Access Compliance Report Public Rights-of-Way (Curb Ramps)

Main Street: SAYBROOKE_LN		Cross Street: NEWKIRK_RD		Location:	N
ADA ID: RPAT211104133108	Ramp Type: Type 4 - Parallel	Initial Pass/Fail: Fail	Overall Compliance: No	Severity Score:	15
Codes/Mitigation Info/Possible Solution			Field Measurements/Component Compliance

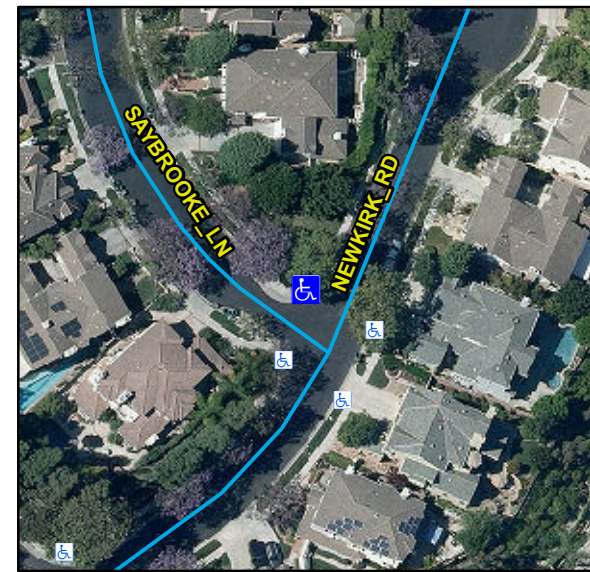
Remove & Replace Curb Ramp With Two New Directional Ramps or Equivalent.
